ADEQUACY OF STATION ELECTRIC DISTRIBUTION SYSTEM
VOLTAGES, BRUNSWICK NUCLEAR POWER STATION UNITS 1 AND 2,
DOCKET NOS. 50-325 AND 50-324

INTERIM REPORT

Technical Evaluation Report

Figure 1. Brunswick Nuclear Station Unit single-line diagram.

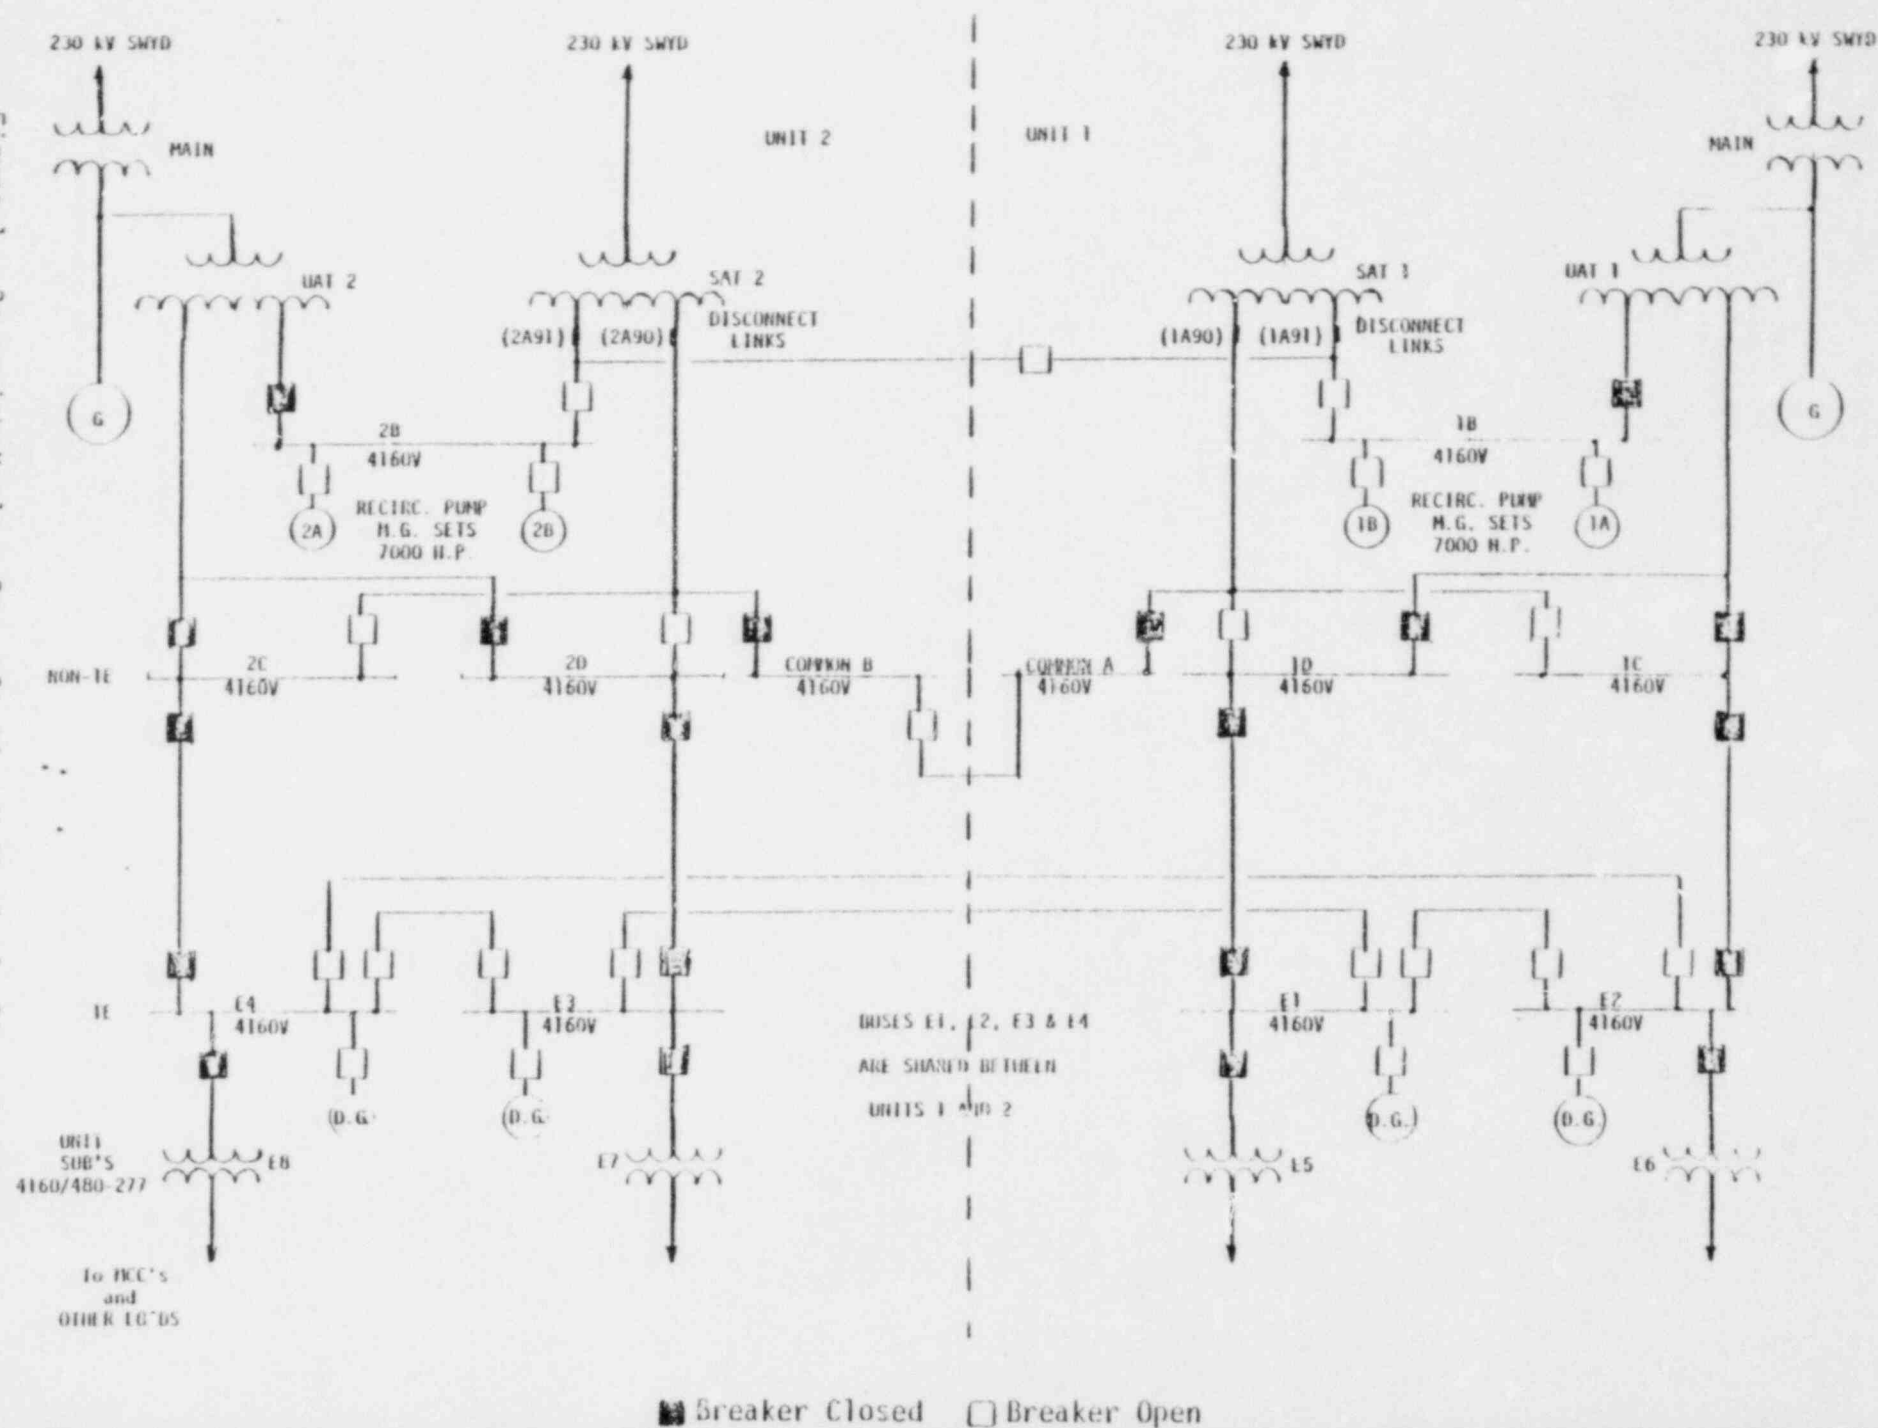
A single-line diagram of the AC electrical distribution system at Brunswick Units 1 and 2 is shown in Figure 1. The breaker positions, open or closed, are shown for normal full-power plant operation.

During normal full-power plant operations, the 1E and non-1E distribution systems are supplied from the Unit Auxiliary Transformer 2 (UAT-2). The Common B bus distribution system is supplied by the Startup Auxiliary Transformer 2 (SAT-2). Protection relays or a unit trip results in the automatic fast transfer of loads from the UAT to the Startup Auxiliary Transformer 2 (SAT-2). The SAT can be supplied from two independent 230kV sources (not shown).

Regarding Unit and bus tie breakers, CP&L states that (a) the tie breaker between non-1E Bus 2B and Bus 1B can only be closed if one of the incoming bus breakers from the SATs in Unit 2 or Unit 1 is open and one of the disconnect links (2A91 in Unit 2 or 1A91 in Unit 1) is removed, (b) the tie breaker between non-1E 4160V Common B of Unit 2 and Common A of Unit 1 can only be closed if the incoming bus line breaker to one of the buses is open, (c) the 1E tie breakers between 1E 4160V E4 or E2 and between E3 and E1 are normally open, and an accident signal will cause them to trip should they be closed, and (d) the 1E tie breakers between E4 and E3 have been disconnected and racked out.⁴ The 480V tie breakers between E8 and E7 (not shown) are normally open.

CP&L has indicated that the tie breaker between Units 1 and 2 is open during normal full-power operations,³ except that the tie breaker between Common A and Common B may be closed^{6,9}. The status and use of these tie breakers is described in Section 3.0 of this report. Included in the CP&L analysis is the case where SAT-2 is supplying all Unit 2 loads with the tie breaker between Common A and Common B bus closed and a LOCA in Unit 2 and a false LOCA signal in Unit 1.⁶ It should be noted that the CP&L analysis considers terminal voltages to non-1E equipment as well as 1E equipment. Although Tables 1 and 2 (based on a grid voltage of 0.96 pu) show satisfactory voltages for the 1E equipment, the CP&L report recognizes degraded conditions for non-1E equipment, which indicates that the switchyard voltage should not be degraded below 97.2%. Therefore, CP&L has proposed modifications should the grid degrade to 97.2% and the tie breaker between Common A bus and Common B bus is closed. These modifications would improve the minimum values noted in Tables 1 and 2.
